AGENDA
REGULAR MEETING OF THE BIRMINGHAM PLANNING BOARD
WEDNESDAY JANUARY 25, 2023 – 7:30 PM
151 MARTIN ST., CITY COMMISSION ROOM 205, BIRMINGHAM MI*

- E.** Unfinished Business
- F.** Rezoning Applications
- G.** Community Impact Studies
- H.** Special Land Use Permits
 - 1. **34350 Woodward – Fred Lavery Porsche – Request for Special Land Use Permit for New 3-Story Auto Sales Agency**

- 2. **479 S. Old Woodward – Birmingham Tower – Request for Special Land Use Permit for New 5-Story Mixed-Use Building.**
- I.** Site Plan & Design Reviews

SUBJECT: 34350 Woodward & 909-911 Haynes Street - Fred Lavery Porsche – SLUP Amendment and Final Site Plan and Design Review

PLAN C2.1
Elm / Haynes & Woodward Intersection + Crosswalks

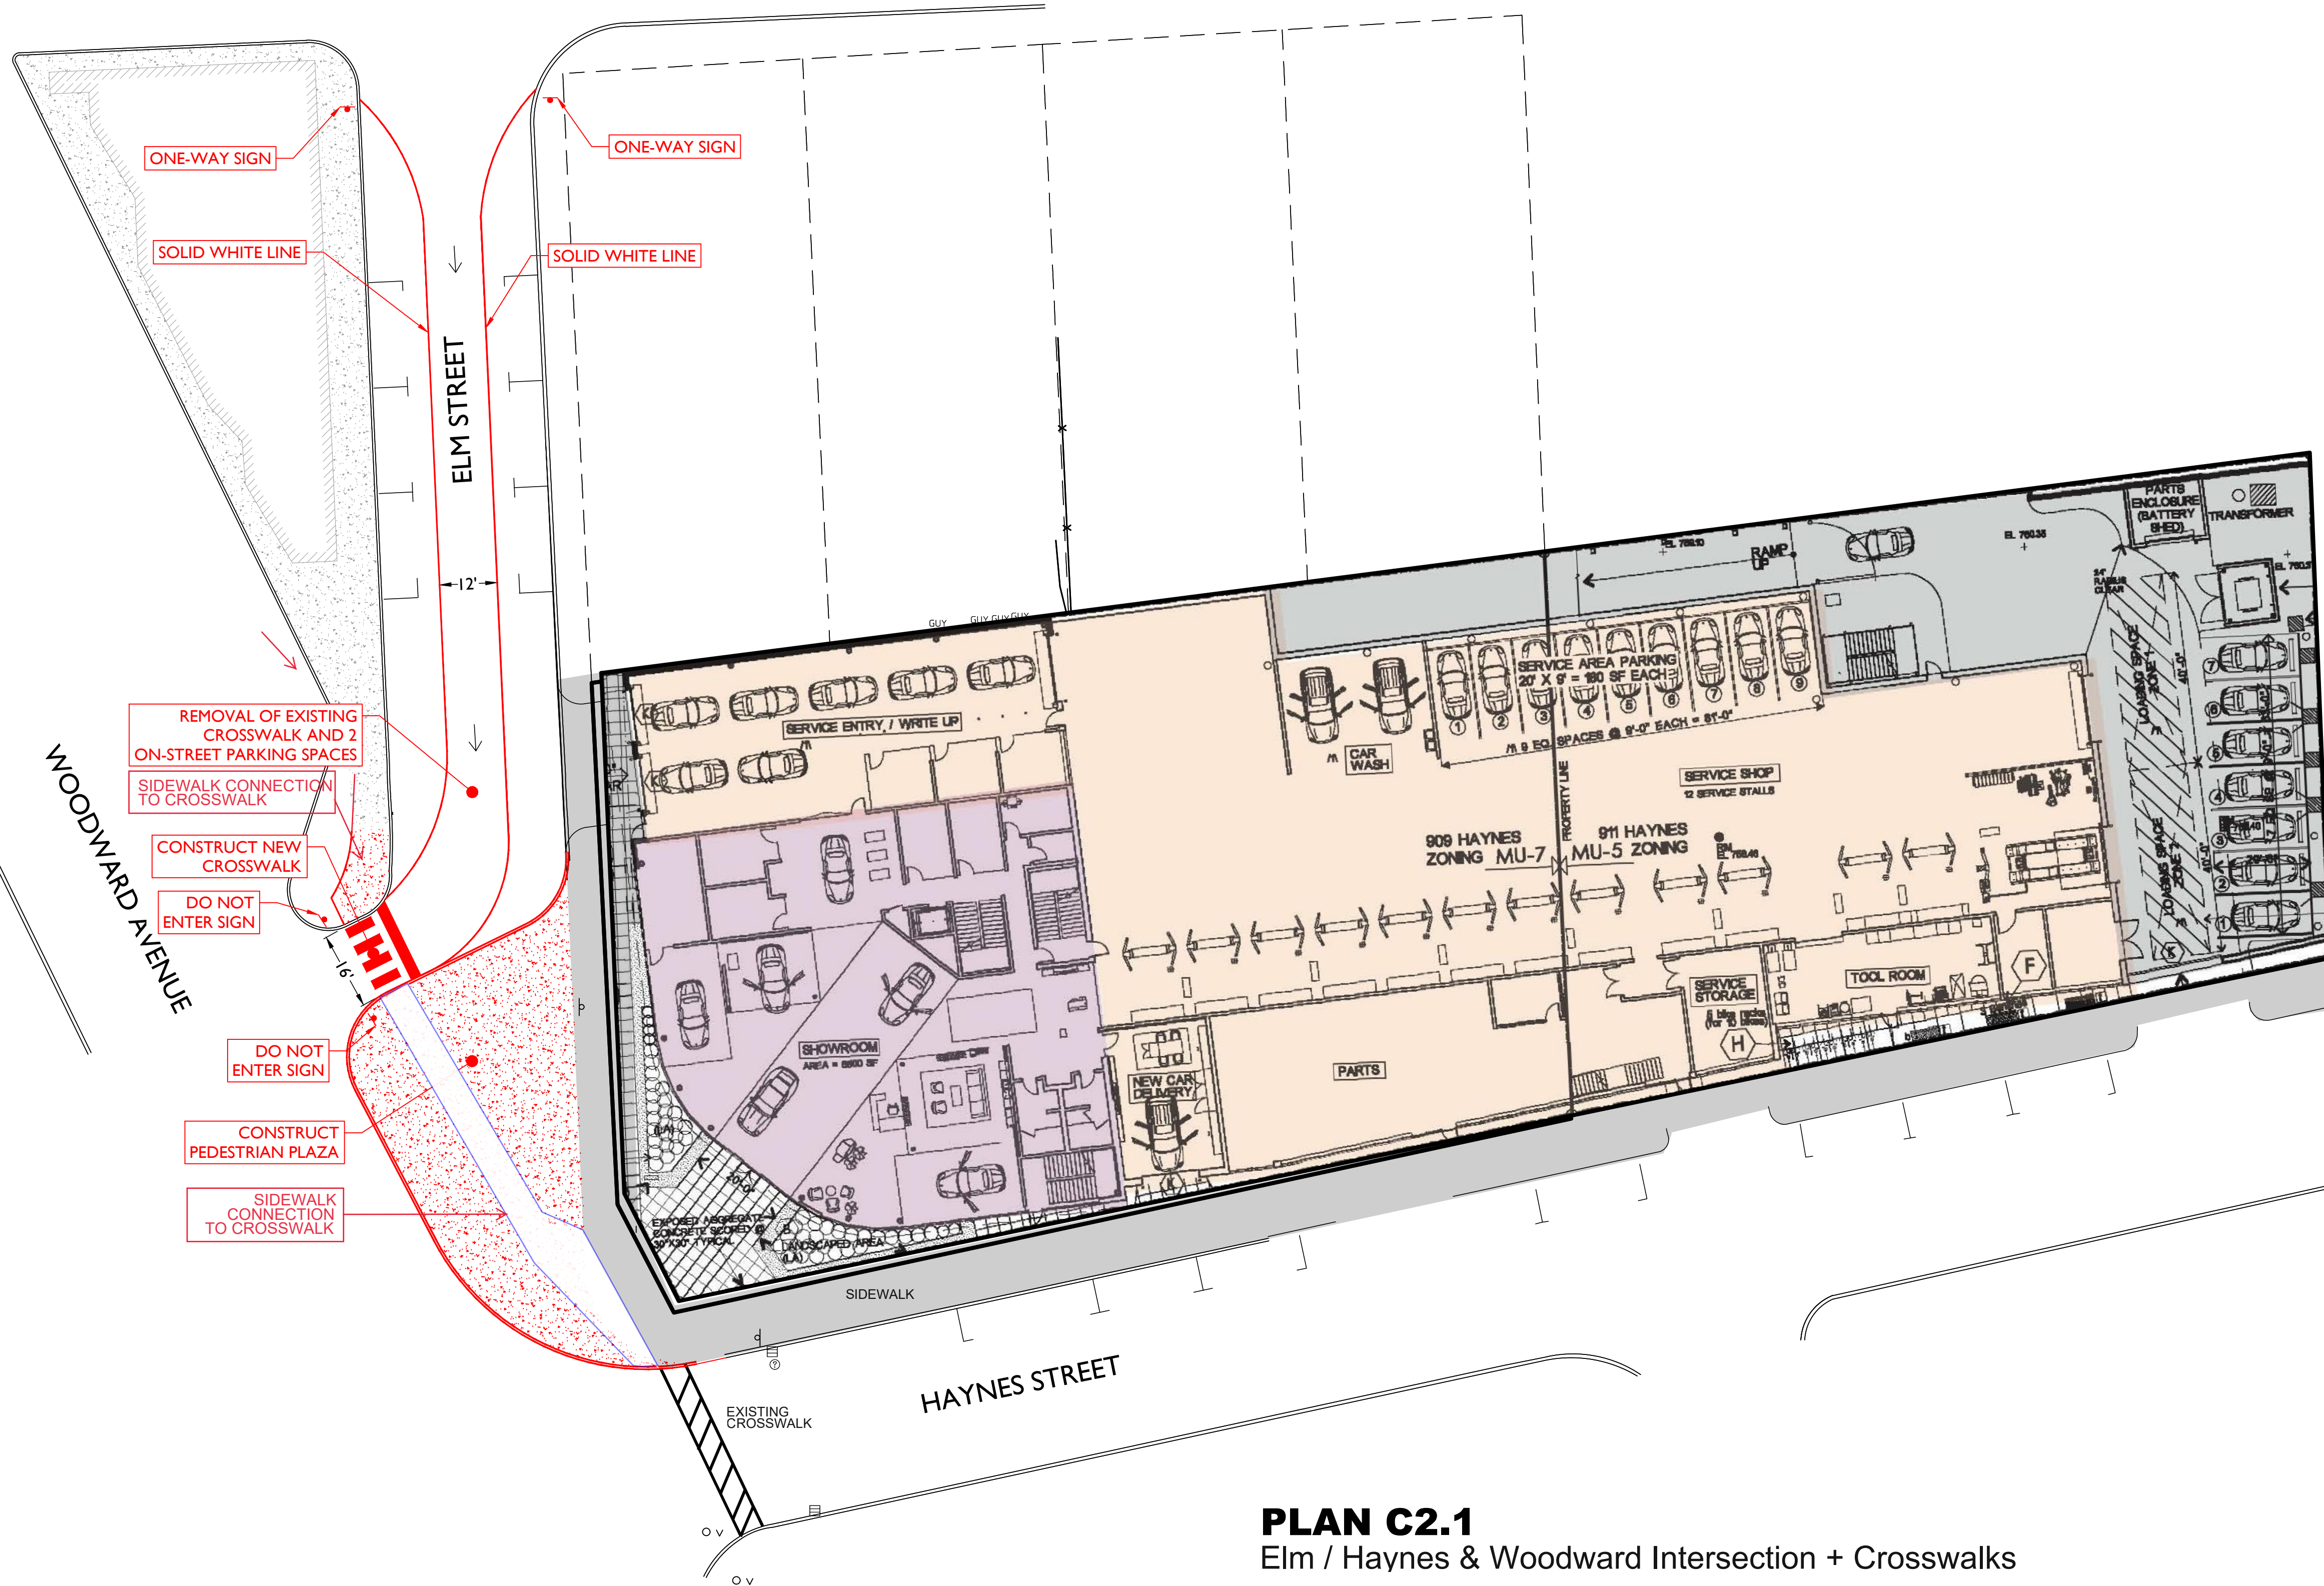
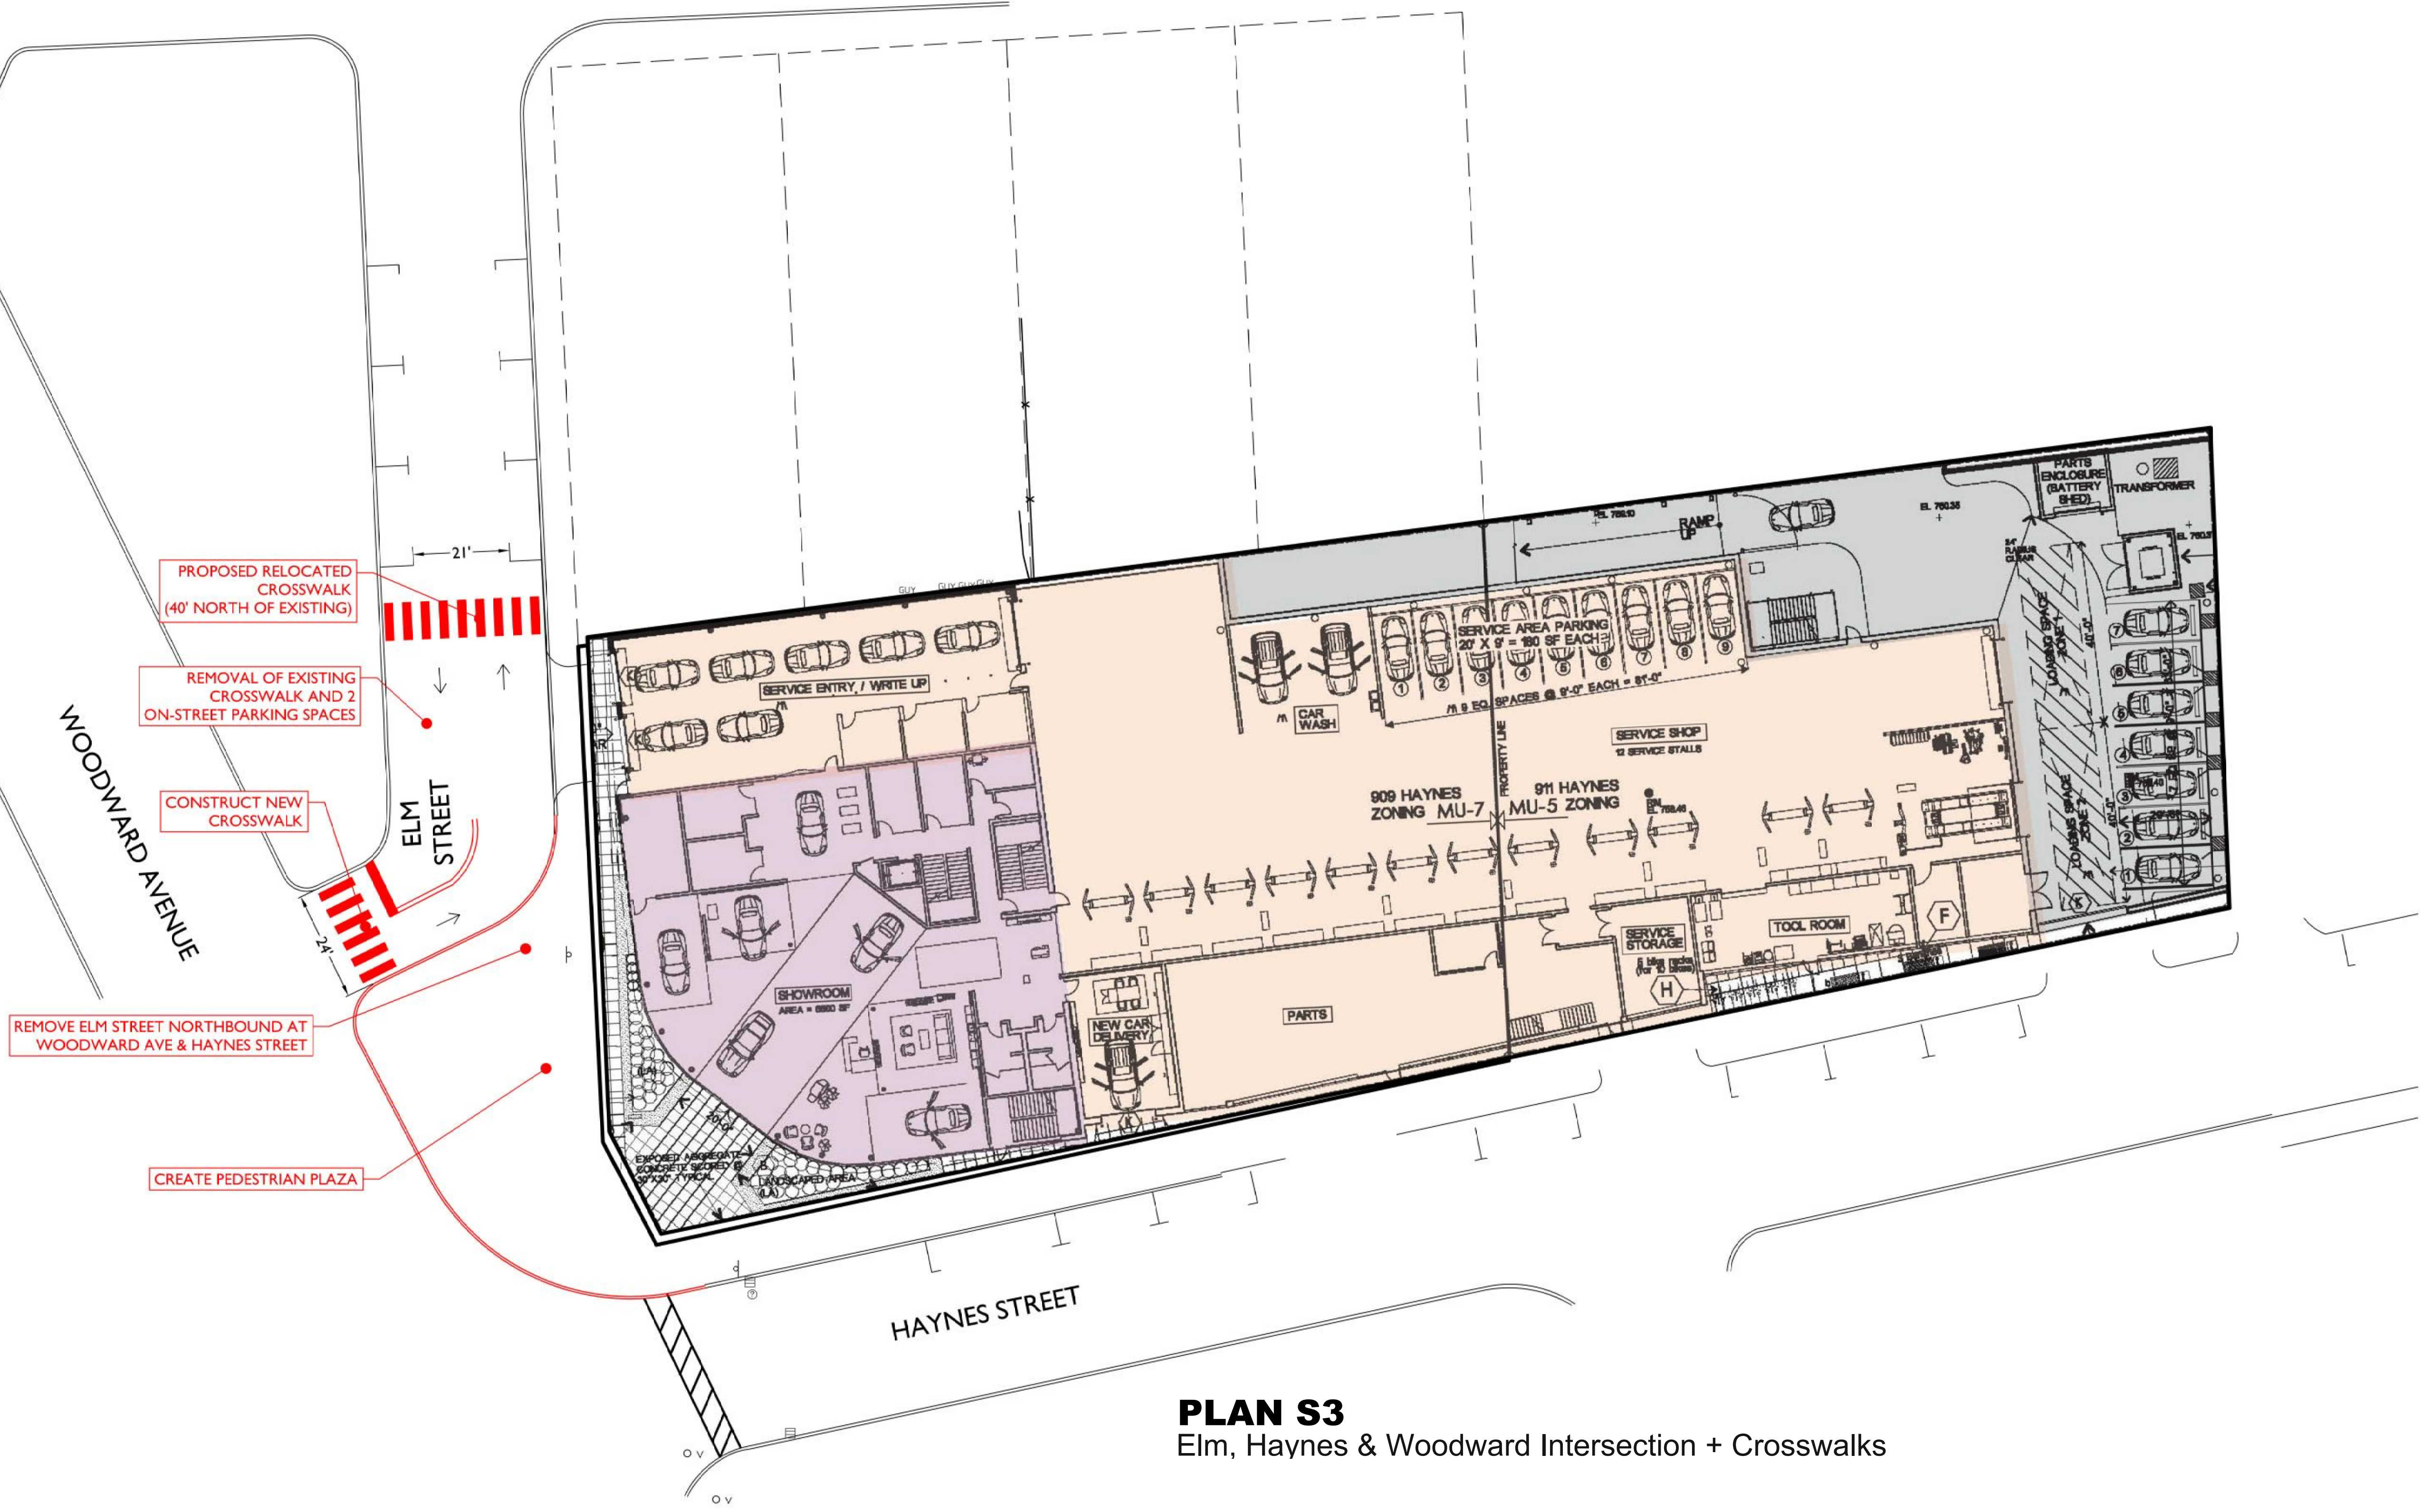
The applicant has provided two different concepts for updating the vehicular and pedetrian access to the intersection of Haynes Street, Elm Street, and Woodward Ave. One concept is option C2 from the Triangle District Plan as recommended by the MMTB. The other concept incorporates recommendations of option C1 of the Triangle District Plan where Elm Street remains a two-way street. The extended bumpout of option C1 would require northbound cars on Woodward Ave to slow down to complete the right turn onto northbound Elm Street.

The Planning Division requests that the Planning Board recommend a preference for the Triangle District Plan's recommendations for Elm Street in relation to the proposed project and provide direction for the applicant regarding options C1 or C2 with Elm Street being a one way or two way street.

As previously mentioned, a concern of City staff is that there is a pedestrian crosswalk in the Elm Street location where the applicant is proposing a curb cut for a garage to the service area. Options C1 & C2 of the Triangle District Plan attempt to address issues of the vehicular speeds and pedestrian crossings at this intersection. The Planning Division recommends that the Planning Board discuss their preference of options for Elm Street in order to enhance the pedestrian safety of crossing Elm Street near Woodward Ave.

2. The applicant provide option (C1 or C2) as indicated in the submitted proposals of the Triangle District Plan's recommendations for Elm Street to be included in the site plan and proposed survey before the public hearing with City Commission;

ELM STREET ELEVATION
% GLASS BETWEEN 1' & 8'

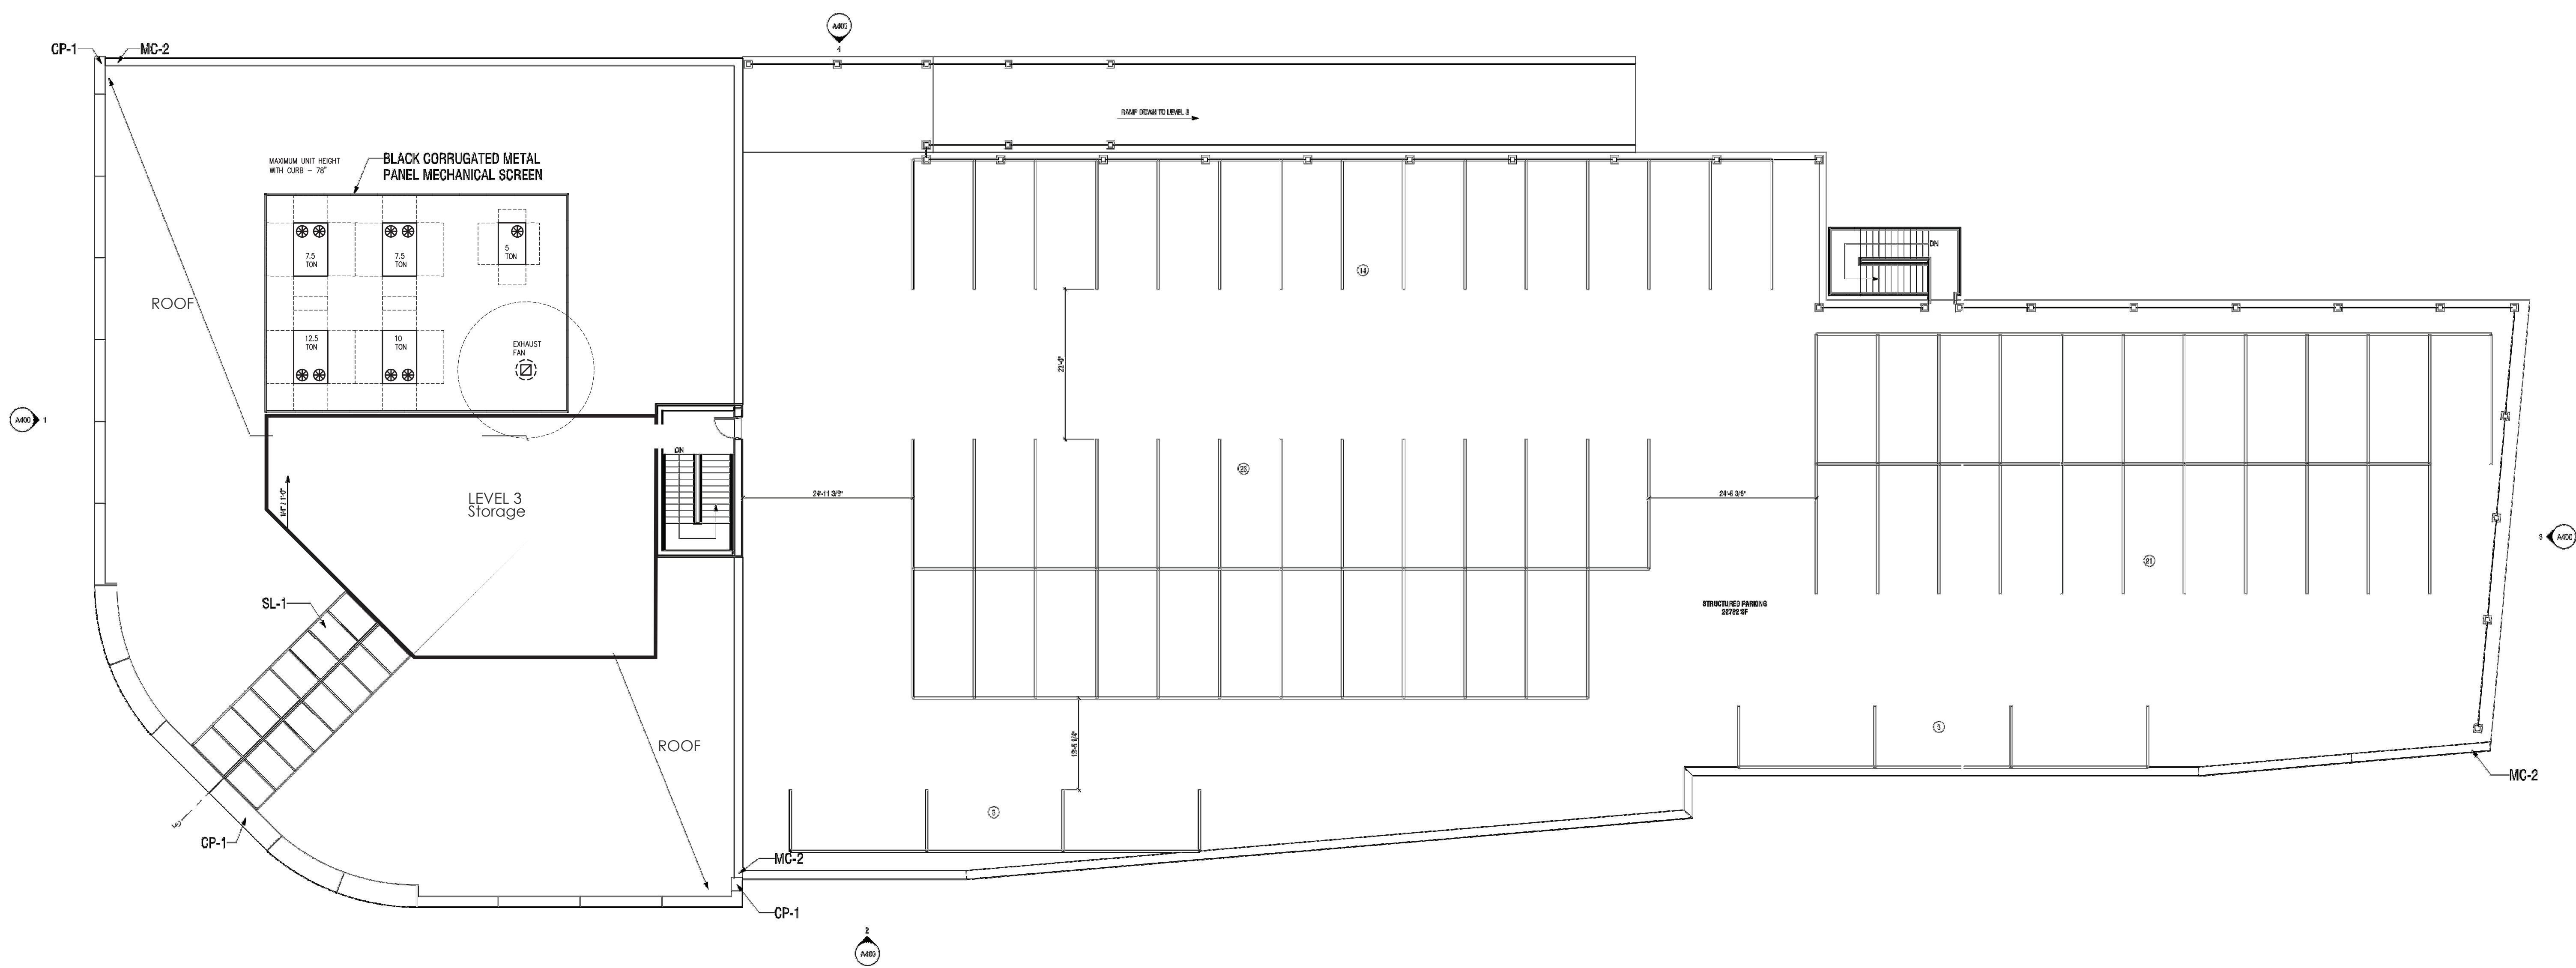
In regards to ground floor glazing, the first floor of the Haynes Street elevation has a glazing percentage of 86.7% and the first floor of Elm street has a glazing percentage of 87.2%. Both street facing elevations satisfy the glazing requirement of 70% minimum between 1-8 feet from ground level. The applicant must provide staff with glass specification sheets to verify that the glazing meets the requirements of 66% visual light transmittance and reflectivity of 15% or less.
